Access Compliance Report

Public Rights-of-Way

(Curb Ramps)

Intersection ID: 18084	Main Street: E_WOODLAWN_RD	Cross Street: FAIRBLUFF_PL	Location: SE
ADA ID: 344623A8AC96	Ramp Type: Perp	Initial Pass/Fail: Fail	Overall Compliance: No
		Severity Score: 25

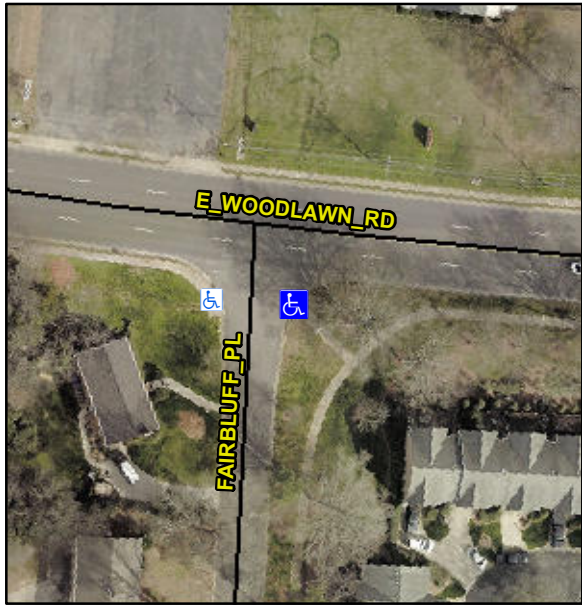
Codes/Mitigation Info/Possible Solution			Field Measurements/Component Compliance					
	Possible Solutions:		Compliance	Description	Data	Compliance	Description	Data
	Remove & Replace Entire Ramp.		N/A	Ramp Length (in)	88.0	Yes	Ramp Slope (%)	7.2
			Yes	Ramp Width (in)	50.0	No	Ramp XSlope (%)	7.7
			N/A	Flare Type LT	N/A	N/A	Flare Type RT	N/A
			N/A	Flare Slope LT (%)	N/A	N/A	Flare Slope RT (%)	N/A
			N/A	Flare Traversable LT?	N/A	N/A	Flare Traversable RT?	N/A
			N/A	Landing Length (in)	N/A	N/A	DWS Provided?	N/A
			N/A	Landing Width (in)	N/A	N/A	DWS Contrast?	N/A
			N/A	Landing Slope (%)	N/A	N/A	DWS Length (in)	N/A
			N/A	Landing X Slope (%)	N/A	N/A	DWS Full Width?	N/A
Surveyor Notes:		N/A	N/A	Landing Curb? (Y/N)	N/A	N/A	DWS Offset (in)	N/A
PROW/ADA:		Not Found, R304.5.3	N/A	Shared Landing?	N/A			
			N/A	Gutter Ponding?	N/A	N/A	Gutter Slope (%)	N/A
			N/A	Gutter Lip Ht (in)	1.0	N/A	Gutter X Slope (%)	N/A

N/A	Painted X Walk1?	No	N/A	Painted X Walk2?	N/A
				X Walk 1 Direction	To W		X Walk 2 Direction	N/A
			N/A	X Walk 1 Width (in)	N/A	N/A	X Walk 2 Width (in)	N/A
				X Walk 1 Slope (%)	3.0		X Walk 2 Slope (%)	N/A
				X Walk 1 X Slope (%)	5.0		X Walk 2 X Slope (%)	N/A
			N/A	Ramp inside XWalk1?	N/A	N/A	Ramp inside XWalk2?	N/A
				Road Slope (%)	N/A	N/A	Clear Space?	N/A
				Road X Slope (%)	N/A	N/A	Clear Space to XWalk (in)	N/A
			N/A	Any Obstructions?	N/A	N/A	Storm Grate/Utility Hazard?	N/A
				Obstruction Type			Storm Grate/Utility Type	
					N/A			N/A
						Yes	Surface Condition? (G/P)	Good
Street 1 Name		FAIRBLUFF PL						
Stop Condition-Street 2		StopSign						
Street 2 Name		N/A						
Stop Condition-Street 1		N/A						
Total Cost:		\$ 1850.00
